service bulletin

No. 88-13

Required Spark Plug Wire Replacement

Figure 1.

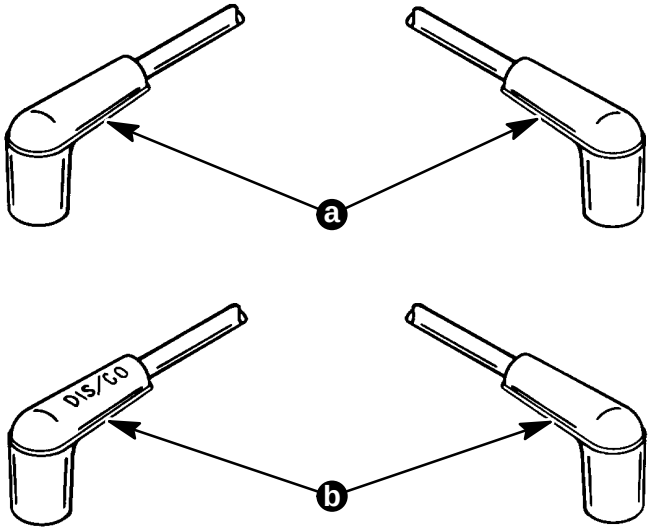
Insulation breakdown only occurs in a certain brand of spark plug wire supplied to Mercury Marine by a vendor. Refer to Figure 1 for identification of the two different wires. Inspect all wires on the engine or in replacement wire sets because sets may have both types of wires in them. If (a) type wire is found, order complete new wire set for engine. Refer to chart for correct ordering information.

a - Approximately 1/8 in. (3.0mm) High White Printing on Wire -This Type of Wire Must Be Replaced

b - Approximately 1/16 in. (1.5mm) High White or Yellow Printing on Wire - This Type of Wire is All Right to Use
